CENTRAL LAND COUNCIL

Submission to the NT Government on

Draft Western Davenport Water Allocation Plan 2023-2033

12 May 2023

Figure - (Upper) Thring Swamp bore RN018338 (Lower) model calibration hydrograph from Knapton, (2017). Note the difference with the model prediction showing the bore fluctuating from ~2-6m below the surface instead of ~0-2m.

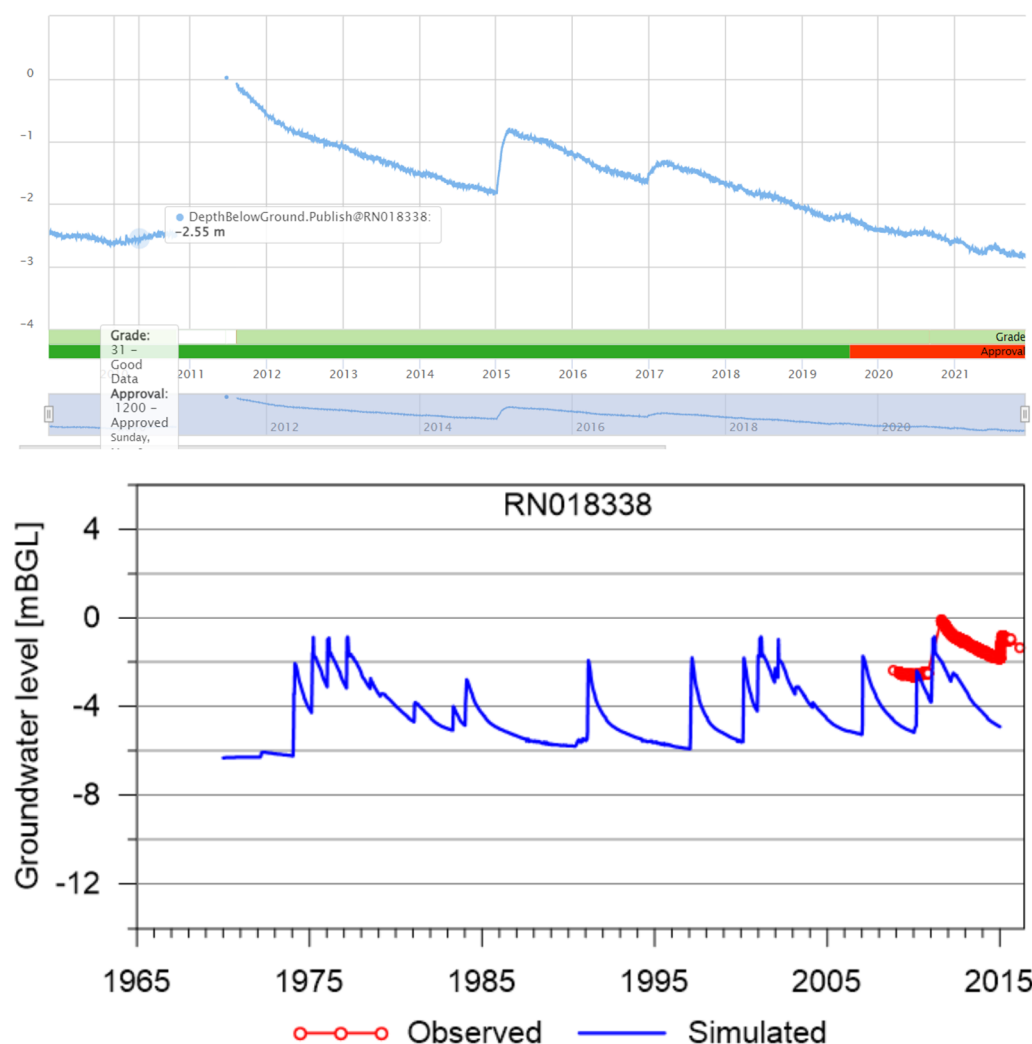
has a depth to groundwater of 5m or less. Available groundwater data from one of the bores near Thring Swamp (see figure below) show that the depth to groundwater at that location is consistently below 5m, has been 0m in 2011 (i.e. at the surface) and is generally about 1.5m. This area is predicted to impacted by drawdown but the lack of predictive uncertainty analysis of the groundwater modelling makes it difficult to assess the timing and magnitude of drawdown. The groundwater model does not accurately (see figure below) represent this important biodiversity asset/high cultural value site, which urgently needs a detailed assessment of aquifer connectivity and groundwater dependence. Showing all depth to groundwater contours <15m at 1m interval would be preferable to facilitate comparison with measured groundwater data.

Figure 6. Cumulative residual rainfall (mm) measured at Ali Curung (BoM Station ID 015502)

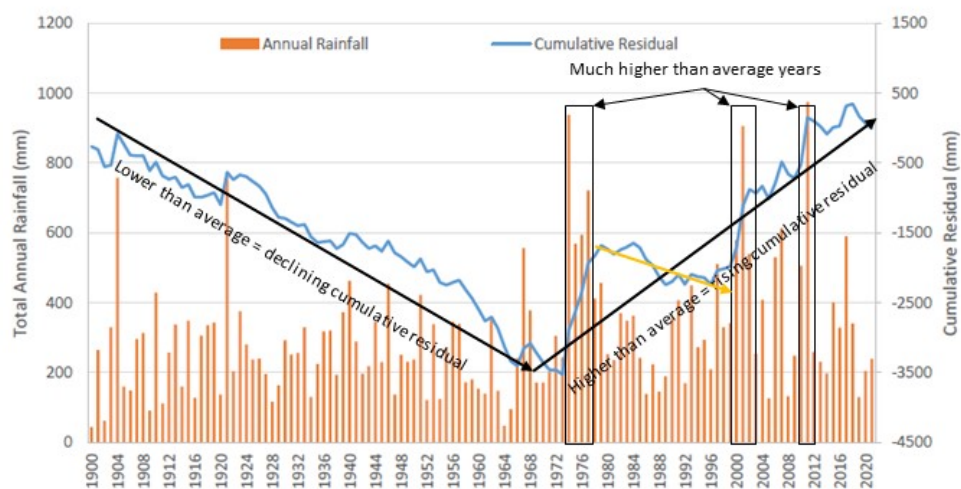
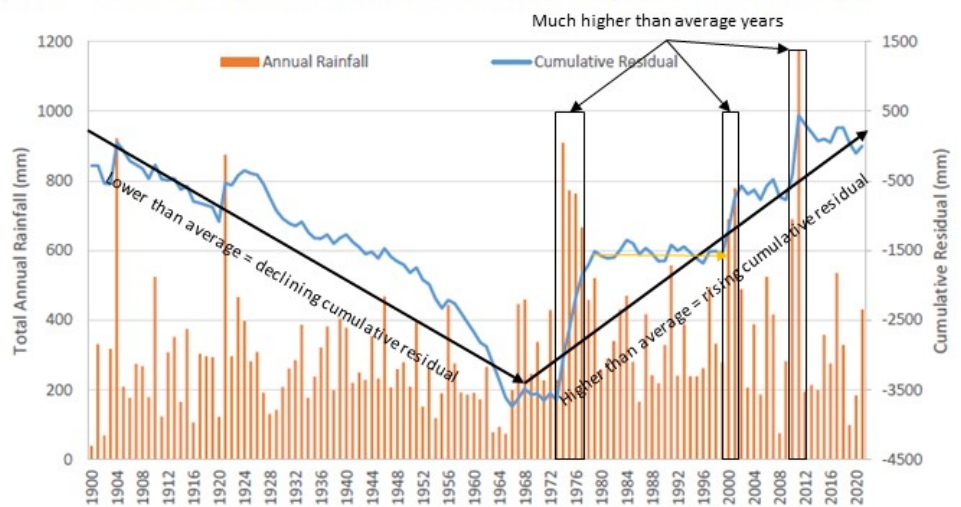
Page 13 - “Both charts provide evidence of an increasing trend in rainfall across the district since approximately 1972.”

Comment - The data isn’t that simple. An annotated version of the climate graph from the WAP background document is shown below. There is a period of average to less than average rainfall that spans 1980 to 2000 (see yellow arrows). The series of 4 significant rainfall years in the late 70’s accounts for about half of the “increasing rainfall trend” at Ali Curung. This effect is even more pronounced in the Barrow Creek dataset with rising trend in the 4 late 1970’s years, 2001, 2002, 2009 and 2010 accounting for this increasing trend.
